**schema 3: revisions to scheme 2**

- REV F 09 Mar 2022 G/M/G  
 The previously approved scheme (scheme 2) is altered to include a number of minor, non-material amendments: the amendments included mostly rationalise the alterations at Rev E
- REV E 06 Sep 2021 G/M/G  
 The previously approved scheme (scheme 2) is altered to include a number of small amendments.
- REV D 15 Jan 2021 G/M/G  
 Planning Application further revised, in response to planning and conservation officers comments.
- REV B 10 Aug 2020 G/M/G  
 Revised Planning Application marked at Revision B
- REV A 05 Dec 2019 G/M/G  
 Original Planning Application marked at Revision A

**PROJECT**  
**The Hoo: Scheme 3**  
**17 Lyndhurst Gardens,**  
**Hampstead, London**  
 Returning a Grand Victorian House to Private Domestic Accommodation NW3 SNU

**DRAWING**  
**Lower Ground Floor Layout**  
**as Proposed**

**DRAWING**  
 Sections AA and BB  
 as Proposed

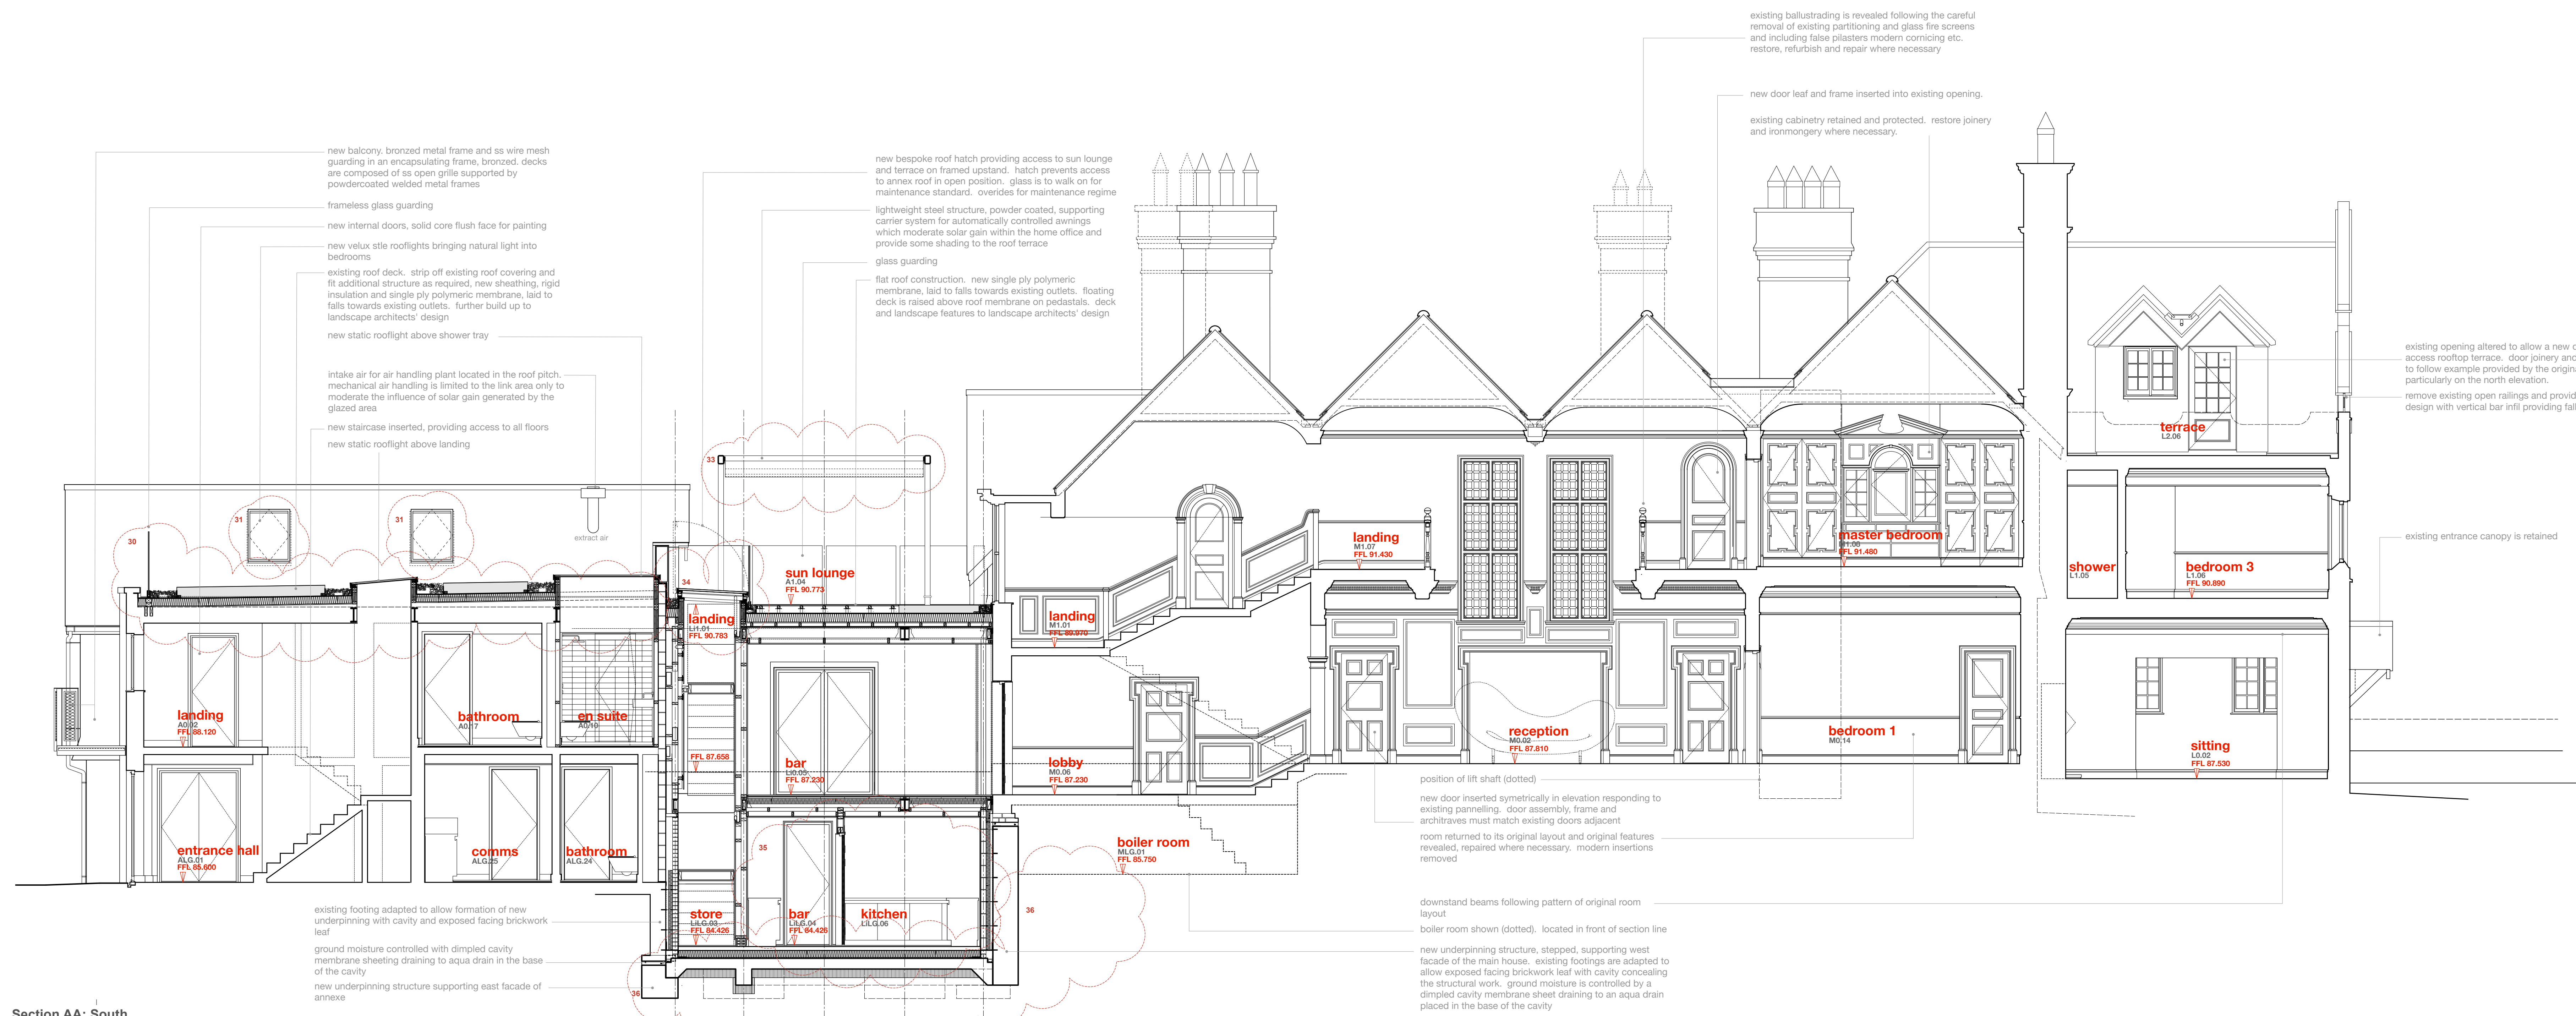
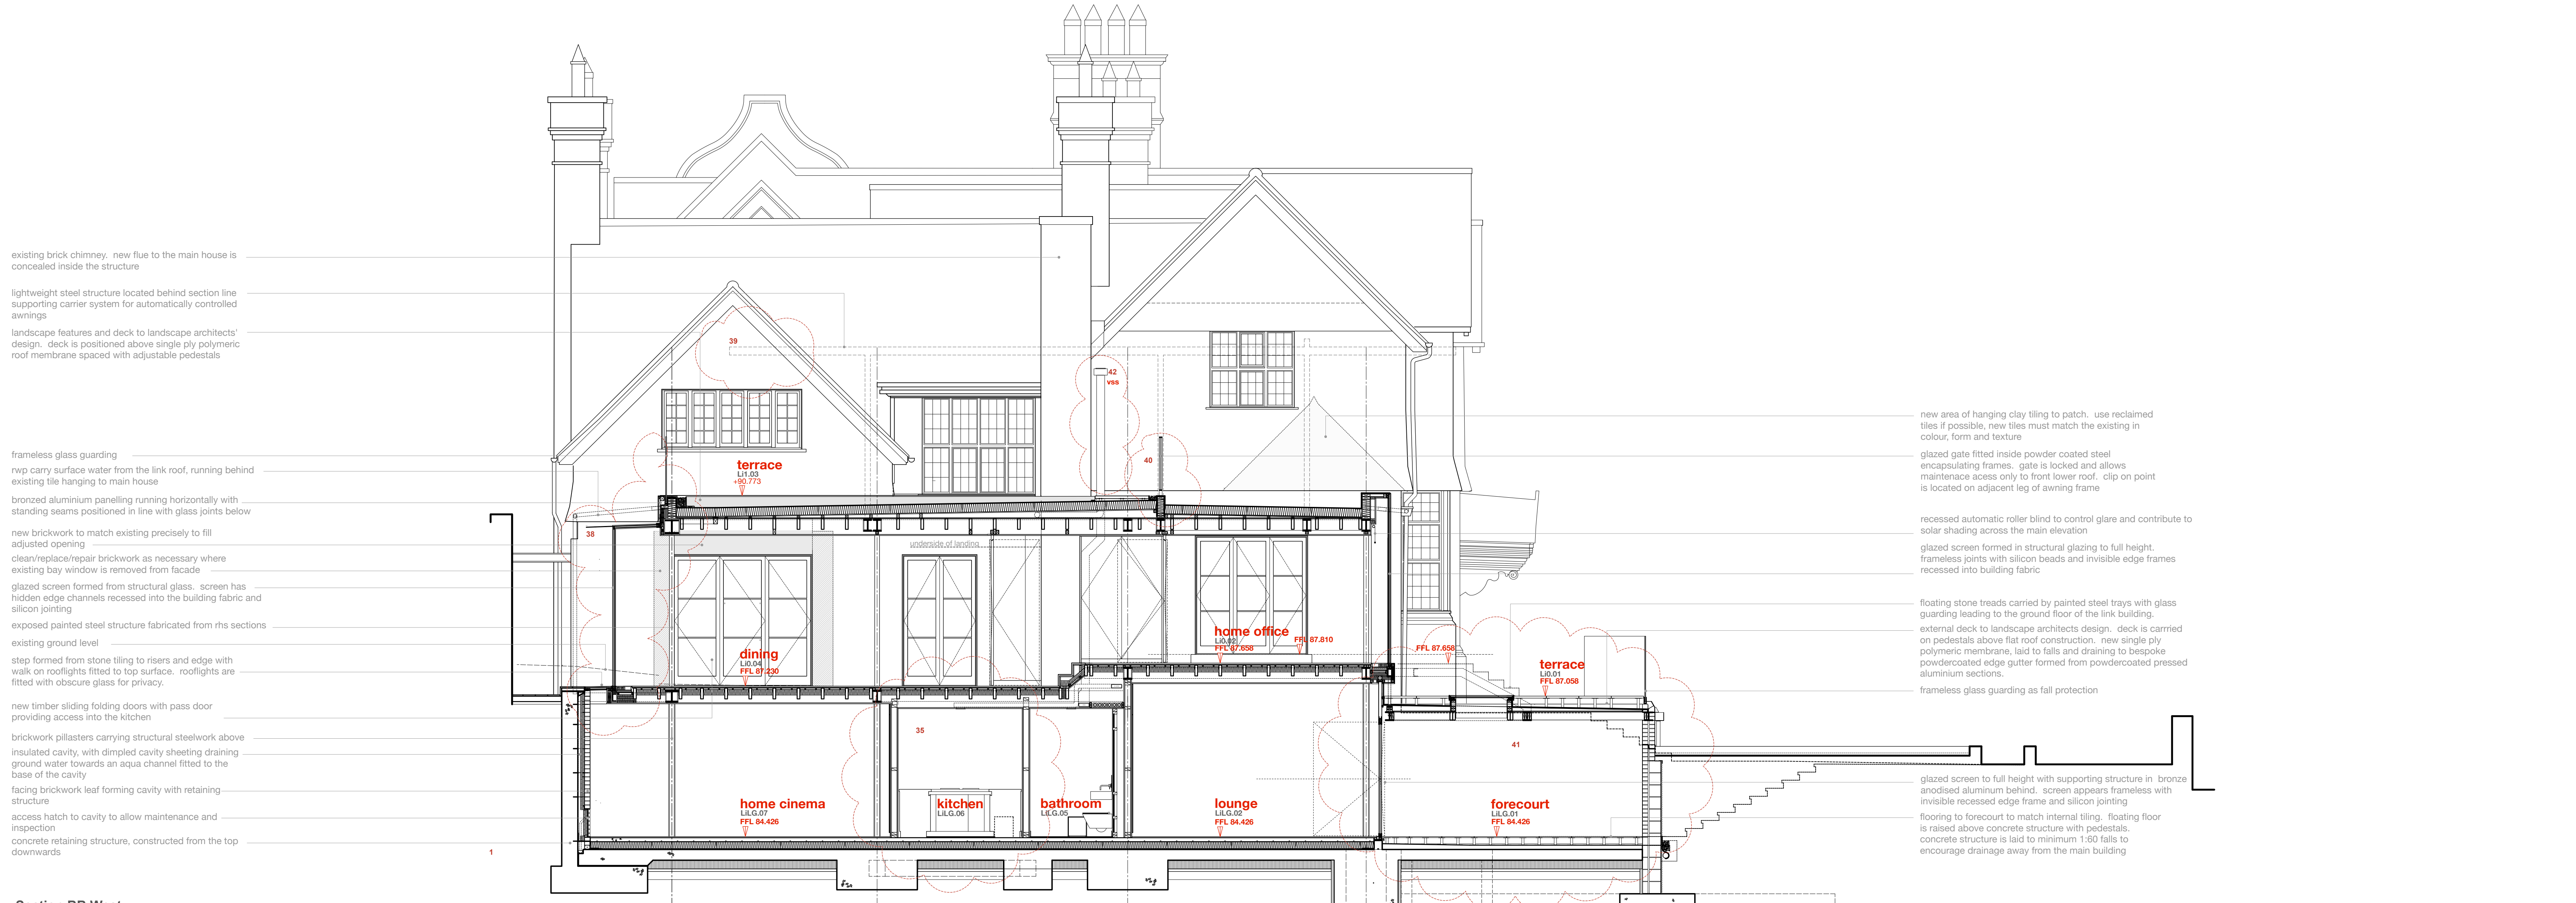
- 30 1980's annex: rooflights are repositioned to suite layout. roof is no longer accessible to the annex and is maintenance access only from the link roof.

- 31 1980's annex: new valux roof lights providing natural light to bedrooms
- 32 link: awnings frame is lifted by 300mm to improve visibility from balconies and to ensure sufficient headroom below painted awning

- 35 link: comms room becomes kitchen, kitchen becomes bar, north wall of kitchen moves further north to provide the ancillary accommodation with more space

- 36 link: design of foundations are refined, formerly proposed new allowing access to plant room is omitted, existing access is expanded to meet fire regulations and used instead.

- 42 new service penetrations including flues, vents, extracts etc. all positions, makes and types and colour/materials identified various locations.
